## Environmental Impact Assessment (EIA) Ordinance (Cap 499) Application for Environmental Impact Assessment Study Brief (EIA SB) (Ref No: f() EP2/N9/C/141 Pt.1)

We refer to your letter dated 23 May 2011 requesting further information concerning the project profile. We are pleased to submit as follow, using your numbering system:

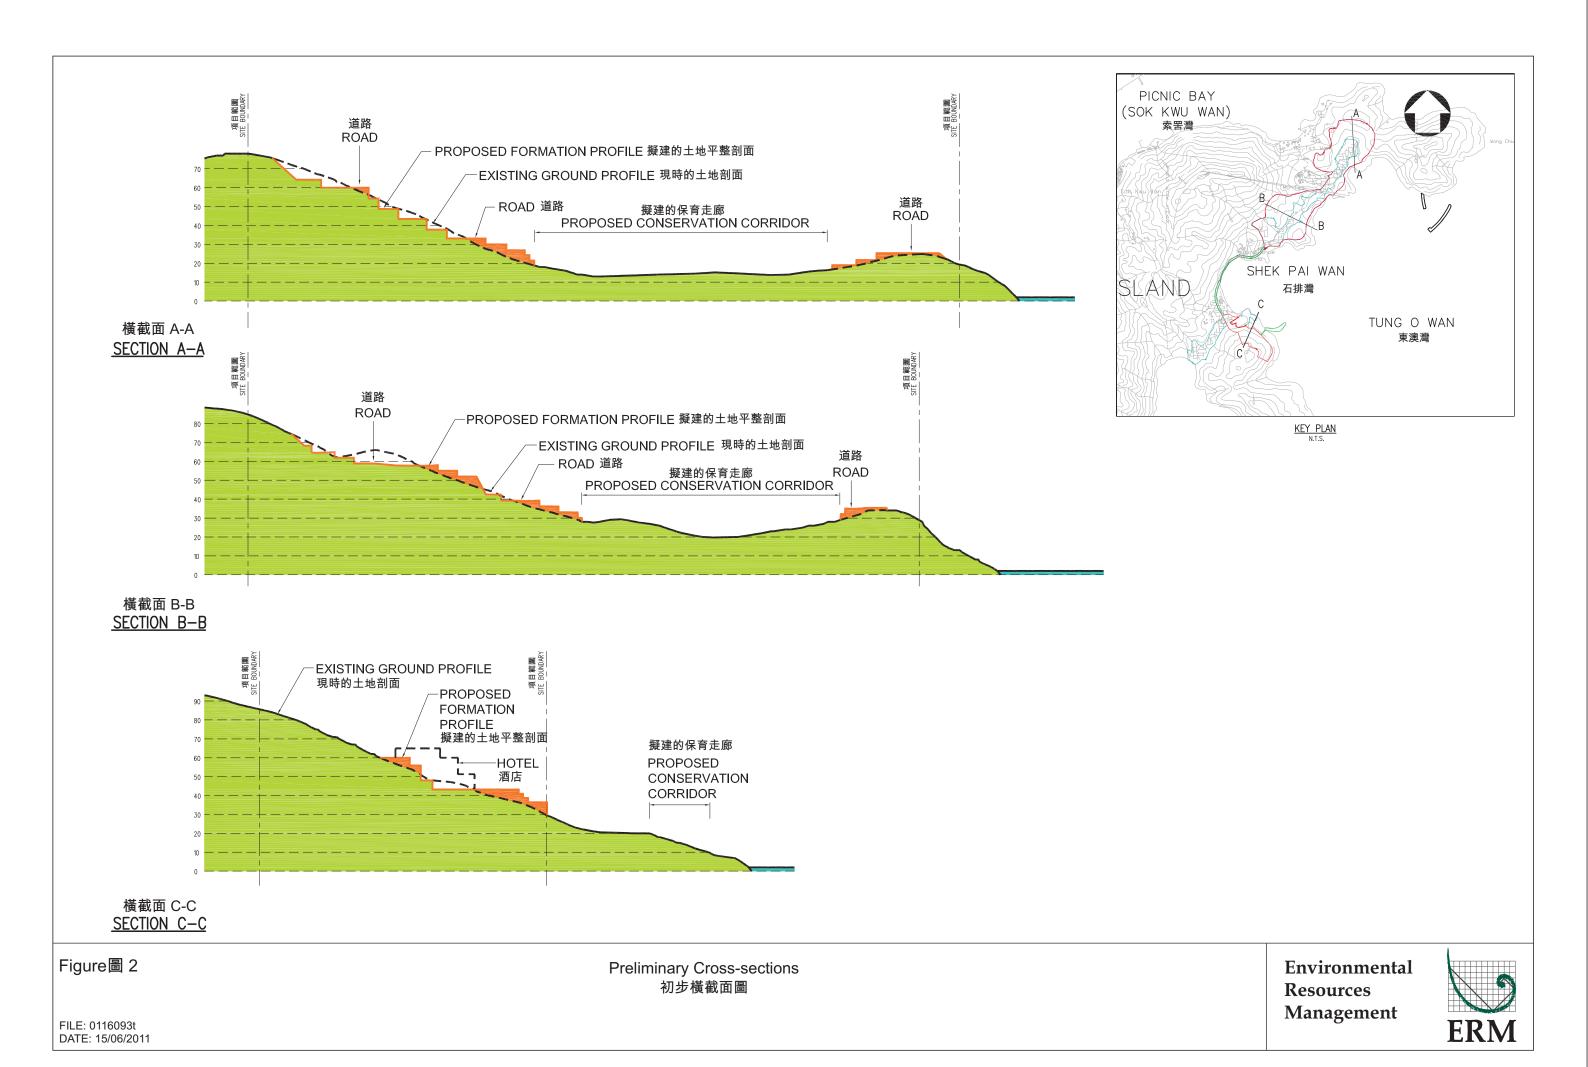
- 1. Preliminary layout plan Figure 1 is hereby attached showing locations of the proposed uses mentioned in section 2.2.1 of the project profile. Kindly note that while a central sewage treatment plant is shown, we are considering alternative arrangement whereby smaller package sewage treatment plants are located at each of the two residential clusters on the northern site, at the breakwater (to serve the marina portion) and at the southern site for the resort hotel.

- 3. The breakwater as indicated in yellow on Figure 1 will be constructed of concrete caissons on rubble mound foundation. Other than that, other facilities are constructed on concrete deck supported by piles. The floating pontoons will mainly be anchored to seabed using cables. A typical arrangement of the concrete deck and supporting piles are shown in Figure 3.

- 4. Our proposal had avoided encroaching into the woodlands and natural perennial streams as far as possible. Please see Figure 4. Utility companies will be responsible for bringing their services to the site and tentatively we expect the entry points will be at locations indicated in Figure 1. The provision of utilities outside the Project site boundary does not form part of the scope of this EIA study."

8. The proposed location of the helipad is shown in Figure 1. As mentioned in Section 3.4 of the Project Profile, the helipad will be located at > 300m from the existing and planned residential developments. It is therefore considered that the proposed helipad will not be classified as a designated project under Item B.2, Schedule 2, part I of the EIA Ordinance, i.e. a helipad within 300m of existing or planned residential development.

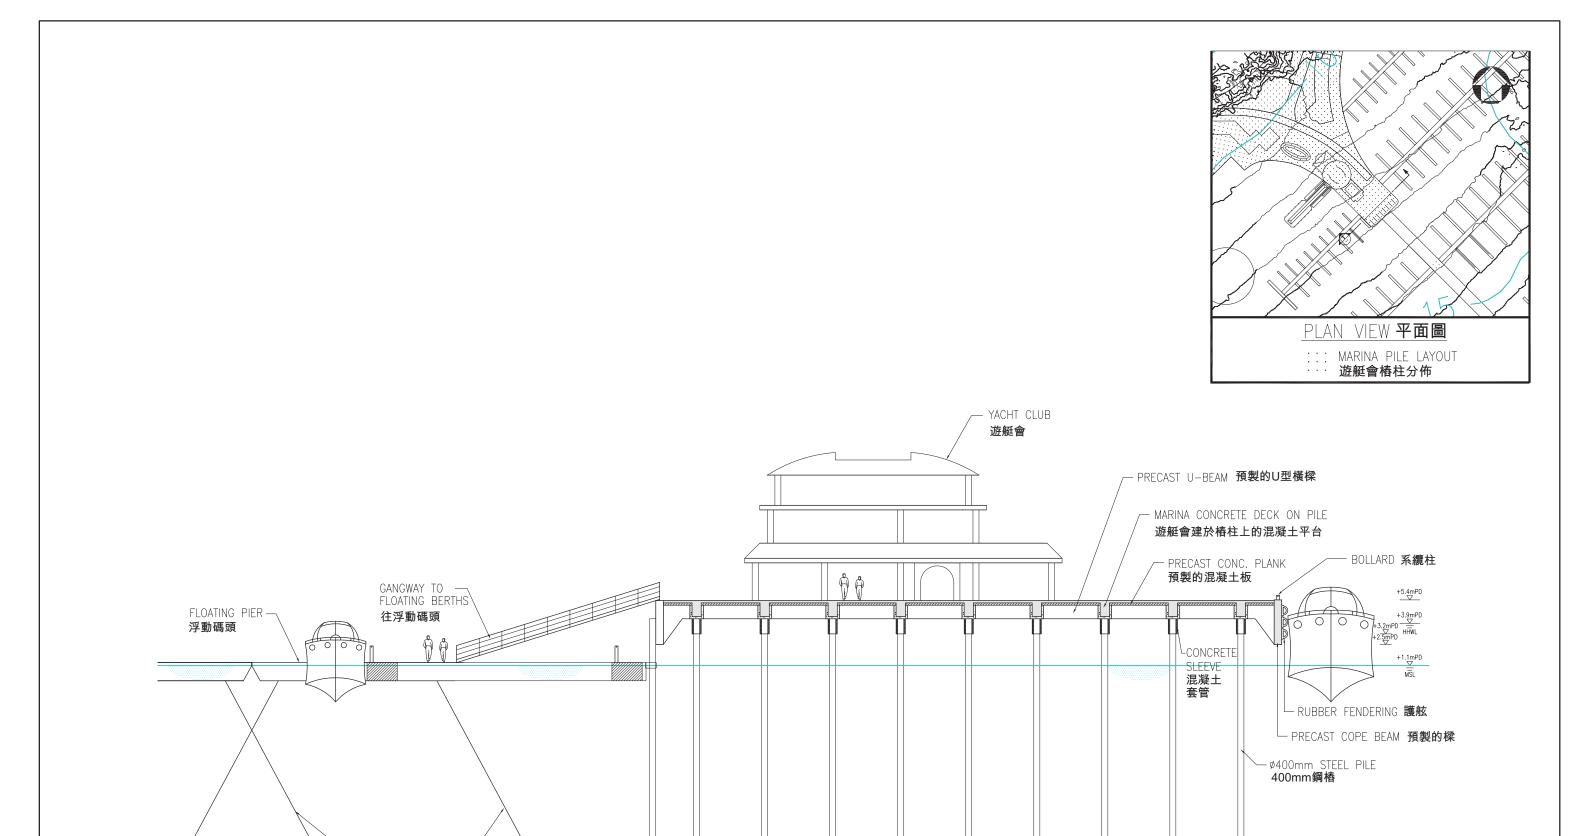
- 2. Figure 2 hereby attached included cross-section plans showing the typical profiles of existing and future terrain for proposed developments on slopes. The intention is to reduce the extent of site formation by terracing to follow the existing topography as much as possible.
